Plan Amendment - Form Systems

TO: Kandice Talbot, Planner
FROM: Jim Wendel, Development Review Coordinator
DATE: August 6, 1997
SUBJECT: Montalvo Corp.
198-208 Riverside Industrial Parkway

Re: Montalvo Corporation
198-208 Riverside Industrial Parkway

TO: Kandi Talbot, Planner
FROM: Steve Bushey, Development Review Coordinator
DATE: April 22, 1997
RE: Montalvo Corporation; 198-208 Riverside Industrial Parkway

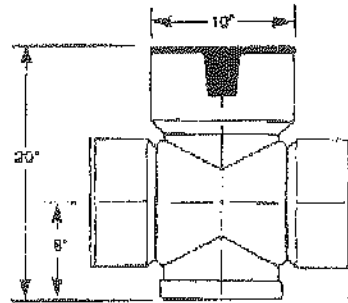
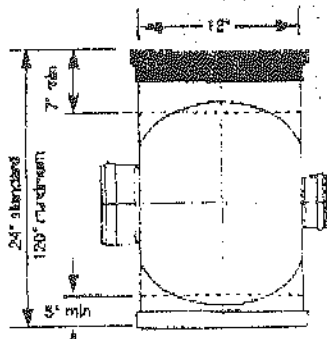
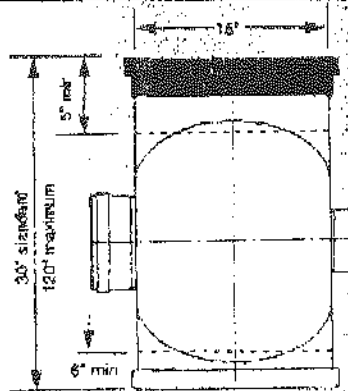
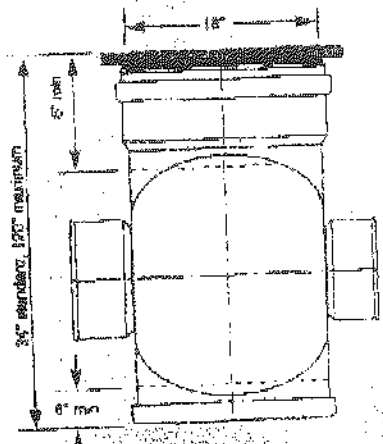
2. The new alignment for the storm drain system is acceptable. However there is a conflict in notation from the grading plan (ABS inlet) and the detail of the truck dock (catch basin); they should submit a manufacturer's detail and data sheet for the ABS inlet for review.

CONCRETE SECTION @
NEW DUMPSTER PAD.

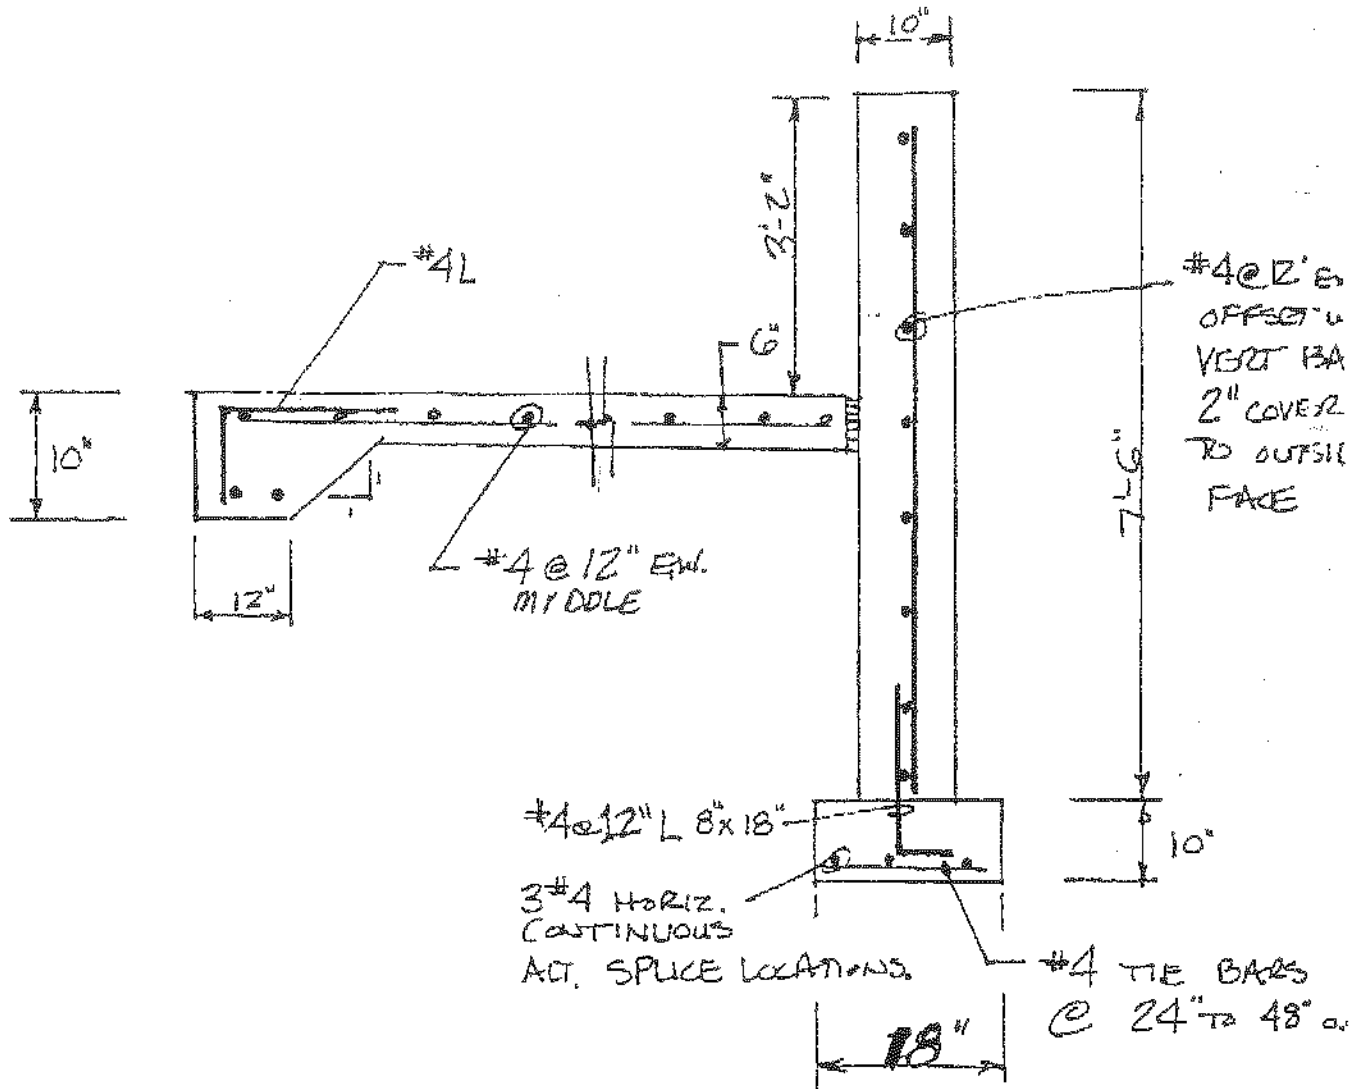
- The dumpster shall be enclosed with a stockade fence. This should be shown on the site plan and also a detail of the dumpster enclosure shall be shown on the plan.
